## PERROW PARK – ADDENDUM #1 SUMMARY

Project Name: Perrow Park  
GMC Project Number: LATL240013  
Addendum Date: June 12, 2025

## SITE PLAN

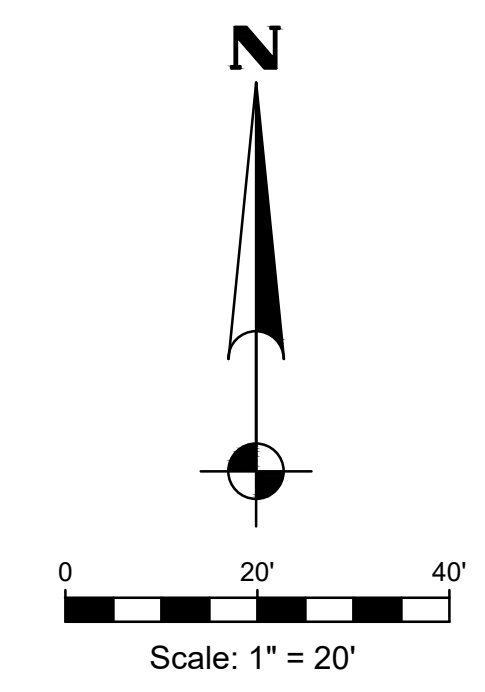
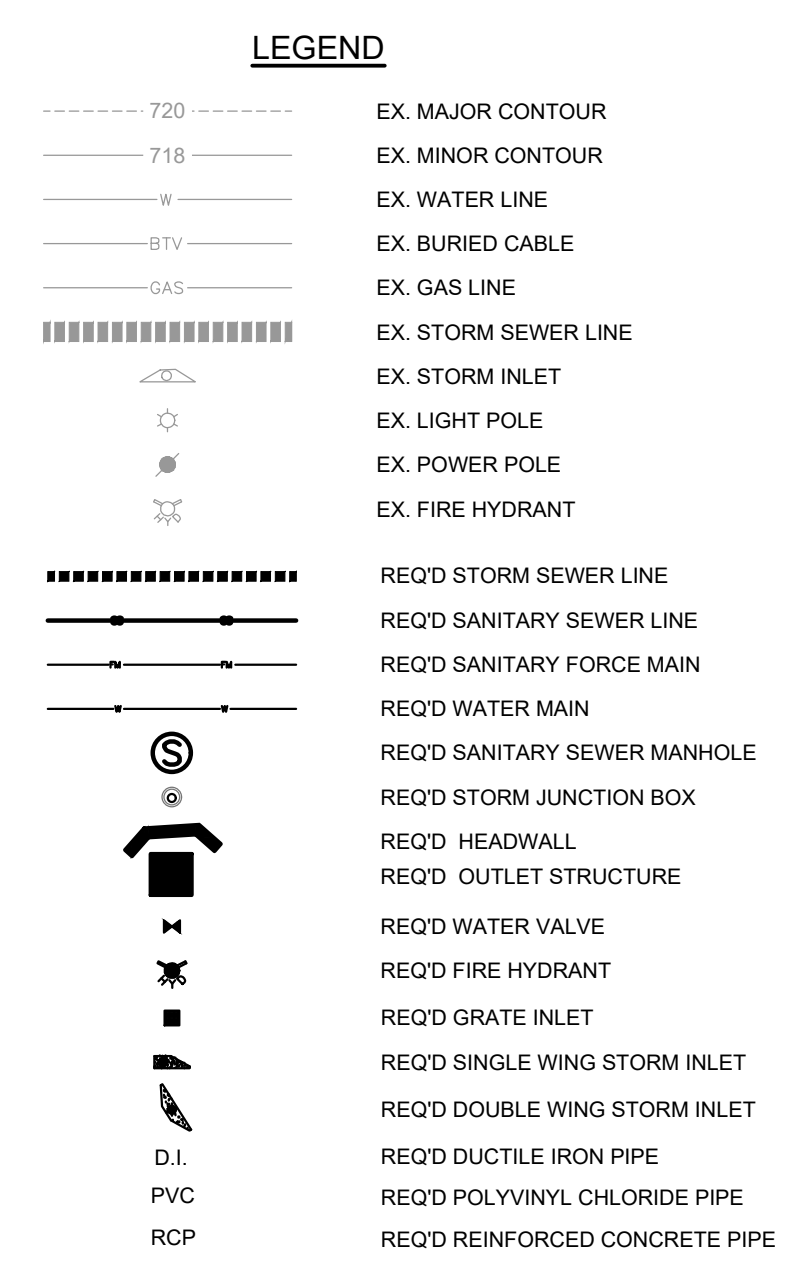
- **Pre-Bid Sign-In Sheet**
- **Bid Questions and Responses**
- **C-003**
  - o Existing shrubs along South Main Street shown as removed by City of Jasper
  - o Existing concrete and asphalt drives along East Spring Street shown as being removed by City of Jasper
- **C-100**
  - o Yield Sign at first entrance on East Spring Street called out
  - o Stop bar, stop sign, and double yellow striping added per GDOT
  - o Sight distance certification added per GDOT
- **C-300**
  - o Septic field layout modified
- **L1.01**
  - o Correct label reference to lighted bollard along southwest edge of event lawn
- **L3.02**
  - o New sheet to include the extents of design-build irrigation areas
